# Memorandum

**To:** Paul Ruesch, OSC, Region 5 EPA  
**From:** John D. Jolly, GEI Consultants  
**CC:** Bryan Heath, NCR Corporation  
**Date:** 5/5/2023 (revised 5/9/2023)  
**Re:** GEI Response to the “Area 4 TCRA Revised Design – Stability Review and “Area 4 TCRA Revised Design – Description of Modeling Errors and Inconsistencies” memos Dated February 15, 2023, Prepared by Jacobs

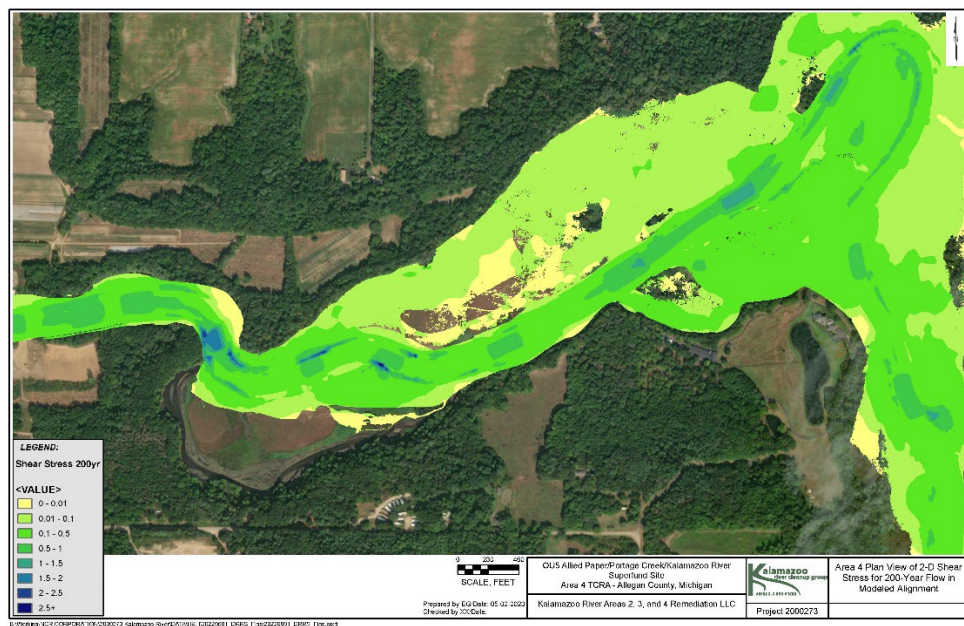
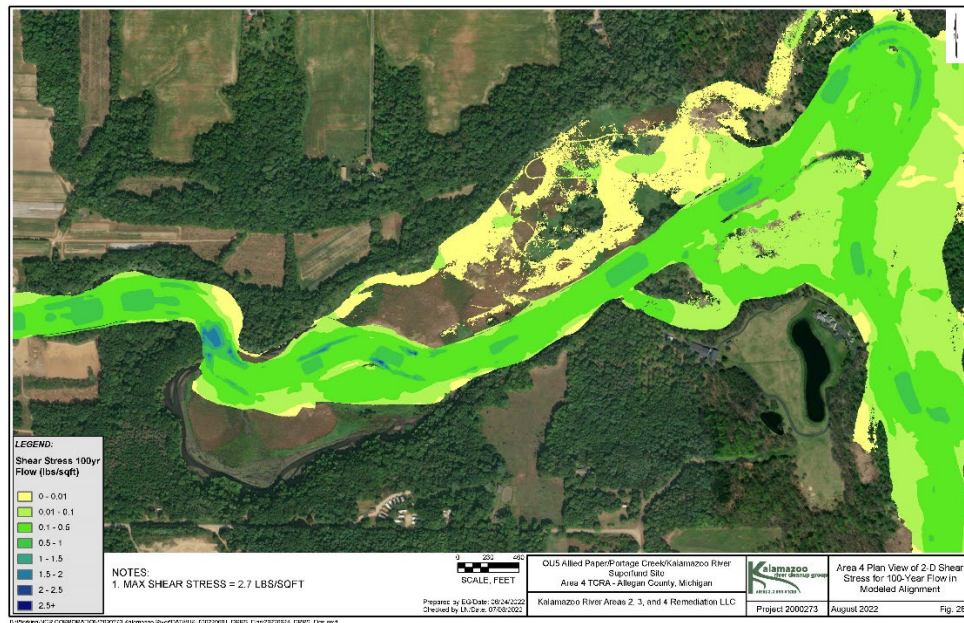
- 9) *Modeling Memo Section 2.2 and Stability Memo Section 1.2. Bed Substrate Based on Most Recent Core Data:* The comment relates to stability of the constructed riffles and potential undercutting.

The modeling work was completed before the most recent (Phase 3) core data were available. The model substrate is based on the data that was available at the time. The  $D_{50}$  from the average surface gradation used in the design model is 0.6 mm, which is representative of the overall gradation of sediment in Area 4 (Area 4 TCRA Hydrology, Hydraulics, and Sediment Transport Modeling Technical Memo; GEI, 2022c). The average  $D_{50}$  from Phase 3 cores is 0.57 mm. In several core samples from all three PDI phases, larger material was observed to fall out of the bottom of the core tube during collection and was therefore not included in the sieve analyses provided in the referenced reports. These observations support the actual gradation being larger than what was used for design. Thus the design constraints GEI used in the work plan are likely more conservative than actual field conditions.

To further assess stability, four additional sediment transport runs were performed in HEC-RAS version 5.0.7. Each run contained stone sizing at each riffle reflective of that specified in the design drawings ( $D_{50}$  = 5 inches, 8 inches, or 12 inches). Each run used a 100-year hydrograph and assumed this event occurred after the completion of the overall channel, bank, and riffle construction. Two of the runs used the AW equation and two used the LC equation. To be conservative, one run with each equation used the gradation from Phase 3 core 4S-PC16-1(0-50) as the gradation for the cross sections in the critical reach rather than at the constructed riffle crests. This core had a  $D_{50}$  of 0.18 mm and did not contain particles larger than medium gravel. In all four runs, the riffle crest elevations downstream of river mile 46.36 remained either at or slightly less than 0.5 ft of the design elevations. The pool and run elevations did show signs of erosion with the finer gradation but they did not erode down to the minimum elevation determined by poling data. In summary, the model using smaller particle sizes indicated some erosion within the proposed pools with negligible movement within the design riffle crests downstream of 46.36. The small amount of predicted movement in this sensitivity analysis does not indicate the need for change in the design.

Longitudinal cumulative volume change for the Area 4 TCRA reach using the LC equation with and without a finer pool gradation over the 7-year simulation.

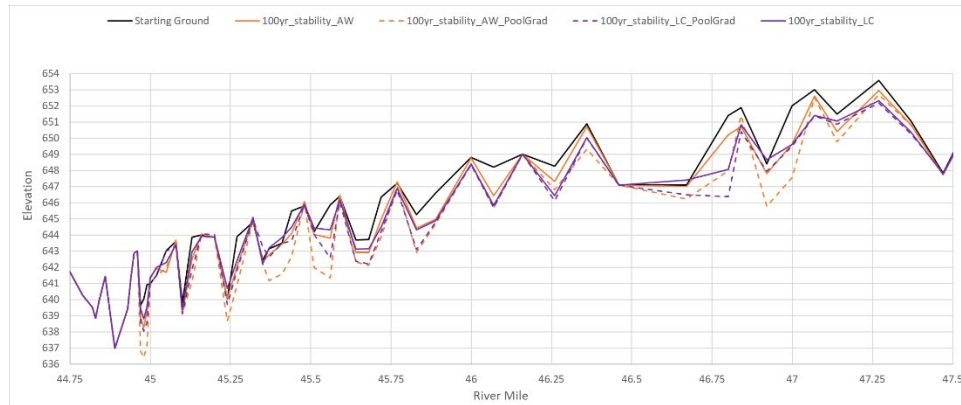
- 8) *Modeling Memo Section 2.1 and 2.3: Predictions of Sediment Mobilization:* The comment indicates that GEI’s sediment mobilization estimates are potentially biased low. The comment indicated that 1) bed substrate used in the model may not reflect actual bed substrate and 2) the sediment transport formula used in the submitted model was not the most appropriate formula to use. In particular, the comment requested that the Laursen-Copeland (LC) equation be used for sediment transport, rather than the Ackers-White (AW) equation that GEI had used in the model.

To address the comment about which equation to use, GEI completed a sensitivity analysis using the LC equation and finer pool sediment gradation. The sediment transport model was run using the 7-year dam-out hydrograph with riffle crest gradations reflecting those provided in the design drawings specifications ( $D_{50} = 5$  inches, 8 inches, or 12 inches) and using the LC transport equation. The model was run again under the same circumstances as above and with the assumption that the pool sediment particle size distribution was equivalent to the gradation observed in Phase 3 Core 4S-PC16-1(0-50), which has a  $D_{50}$  of 0.18 mm and no particles larger than medium gravel.

Sediment volumes moving out of the TCRA area at the end of the 7-year simulation using the LC equation were within 1% of the volume moving out of the TCRA boundary using the AW equation. Using both a finer gradation in the pools (discussed further in response number 9) and the LC equation, mobilized sediment volumes were within 7% of the volume noted using the AW equation. See response 10 for further discussion on the LC equation. These small differences in modeled sediment transport do not warrant change to the TCRA design.
